**STAFF RECOMMENDATION**  
**2406 Oakland Avenue**  
**May 19, 2021**

**Application:** New Construction—Addition  
**District:** Belmont-Hillsboro Neighborhood Conservation Zoning Overlay  
**Council District:** 18  
**Base Zoning:** R8  
**Map and Parcel Number:** 10416028500  
**Applicant:** Martin Wieck, Nine12 Architects  
**Project Lead:** Melissa Baldock melissa.baldock@nashville.gov

<p><b>Description of Project:</b> Applicant proposes to remove a non-contributing addition and to construct a rear addition.</p> <p><b>Recommendation Summary:</b> Staff recommends approval of the project with the following conditions:</p> <ol style="list-style-type: none"><li>1. Staff approve the windows, doors, and roof shingle color prior to purchase and installation;</li><li>2. The applicant submit elevation drawings for any outbuilding larger than one hundred square feet (100 sq. ft.) in footprint; and</li><li>3. The HVAC be located behind the house or on either side, beyond the mid-point of the house, and utility meters shall be located on the side of the building, within 5’ of the front corner. Alternative mechanical and utility locations must be approved prior to an administrative sign-o

Figures 2 & 3 (left and center) show the extension that is to be demolished. Figure 4 (right) is the c. 1931 Sanborn map that shows an extension

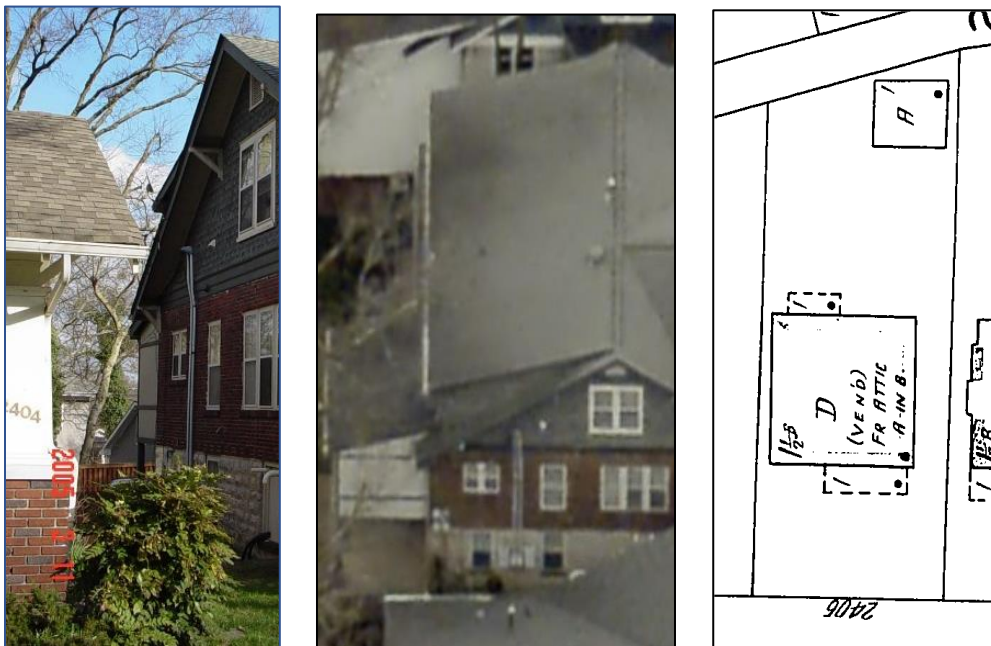
Demolition: The applicant proposes to construct a rear addition at the back of the house. This rear, one story portion with a separate roof form may be the same structure seen in the c. 1931 Sanborn Map (Figures 2, 3, 4). Nonetheless, staff finds that the extension's location at the rear of the house, its separate roof and foundation forms, and its materials do not contribute to the historic character of the historic house. Staff finds that its demolition is appropriate.

Staff finds that the proposed partial demolition meets Section V.B.2. for appropriate demolition.

**SITE PLAN**

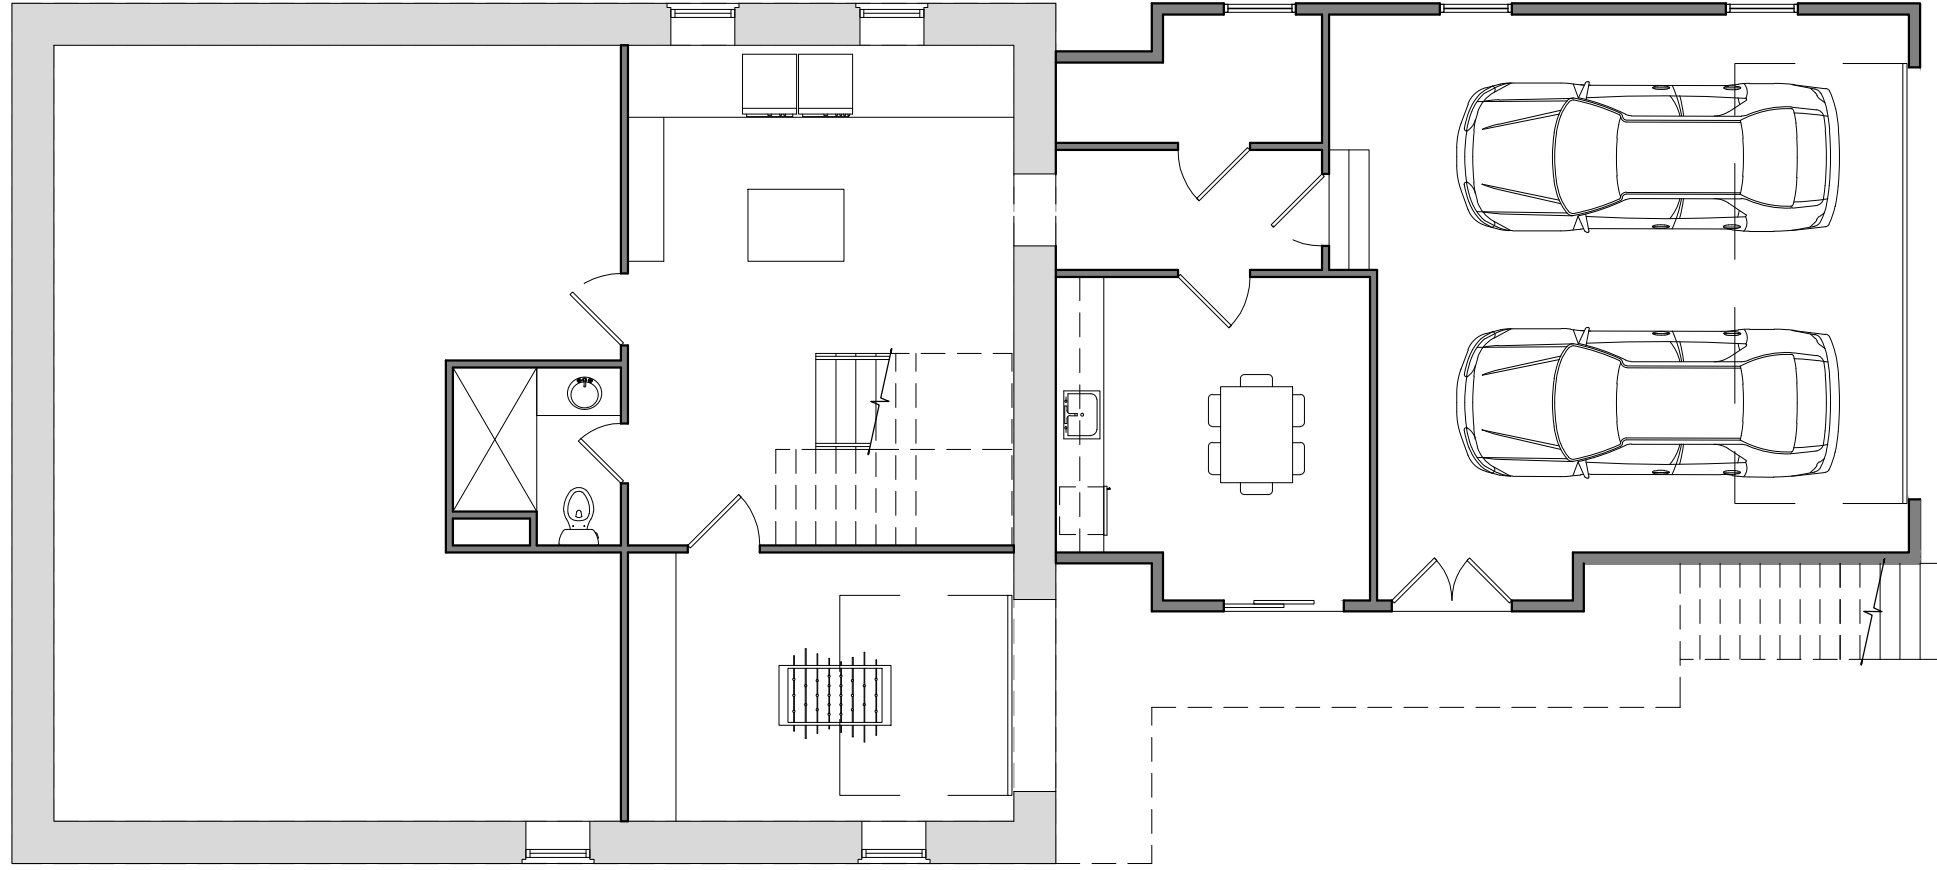
Setback & Rhythm of Spacing: The proposed addition meets all base zoning setbacks. It will be approximately eight feet (8') from the left side property line, sixteen feet (16') from the right side property line, and twenty-three feet (23') from the rear property line.

Staff finds that the addition's setbacks and rhythm of spacing to meet Sections II.B.1.c. and II.B.2. of the design guidelines.

Outbuildings: As mentioned under "Orientation," the addition includes a rear-facing attached garage at the basement level, which meets the design guidelines. The plans indicate that there will be a one-hundred-and-twelve square foot (112 sq. ft.) outbuilding. MHZC must review all outbuildings over one hundred square feet (100 sq. ft.).

Staff finds that the proposed attached garage meets Sections II.B.1.i. and II.B.2. of the design guidelines. Staff recommends that the applicant submit elevations for any outbuilding over one hundred square feet (100 sq. ft.).

1. Staff approve the windows, doors, and roof shingle color prior to purchase and installation;
2. The applicant submit elevation drawings for any outbuilding larger than one hundred square feet (100 sq. ft.) in footprint; and
3. The HVAC be located behind the house or on either side, beyond the mid-point of the house, and utility meters shall be located on the side of the building, within 5' of the front corner. Alternative mechanical and utility locations must be approved prior to an administrative sign-off on building permit(s).

2 WEST ELEVATION  
SCALE: 1/8"=1'-0"

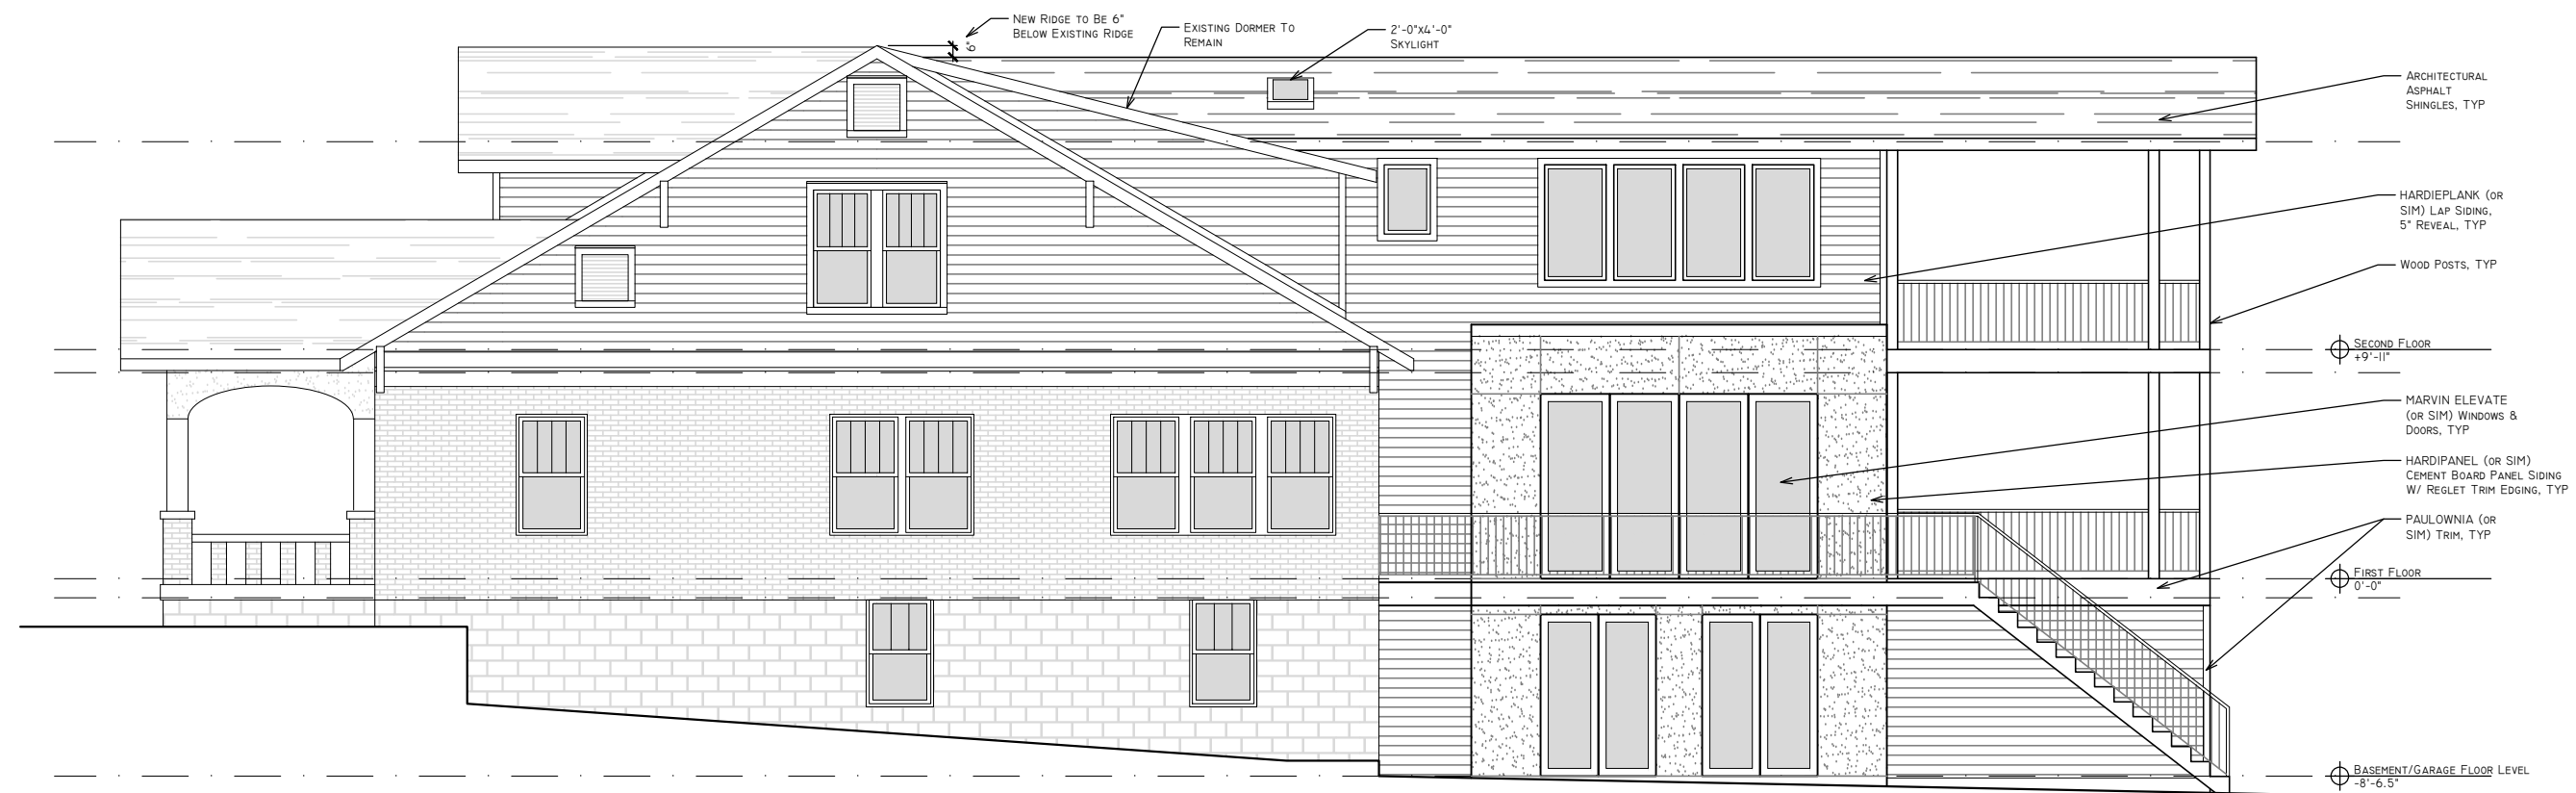
Height & Scale: The proposed addition will be no taller and no wider than the historic house. The ridge of the addition will be located six inches (6") below the ridge of the historic house. Because of the slope of the lot, the addition gains a basement level.

The addition is inset on the left side with a two foot by four foot (2' X 4') inset. This right side of the addition has a one-and-a-half story form, with an eave and foundation height that matches those of the historic house. The dormers on this façade are inset two feet (2') from the wall below, per the design guidelines.

On the right façade, the addition is inset between ten feet, six inches and twelve feet, six inches (10'6"- 12'6") from the back corner of the house. This part of the addition is two stories above the basement level, with an eave height that is about nine feet, six inches (9'6") taller than the historic house's eave. Staff finds that this two stories above the basement level and the taller eave to be appropriate in this instance because the addition is inset over ten feet (10') from the back corners of the house, reducing the visibility of this part of the addition from the street and lessening the impact of the addition on the historic house's architectural integrity.

Roof form: The addition's primary roof form will be a rear-facing gable with a slope of 12/12 on the left façade and 3/12 on the right façade. The dormers on the left façade will be gabled and will be inset at least two feet (2') from the side wall of the historic house, which meets the design guidelines.

Staff finds the proposed roof forms to be compatible with the historic house's roof forms and to meet Sections II.B.1.e. and II.B.2. of the design guidelines.
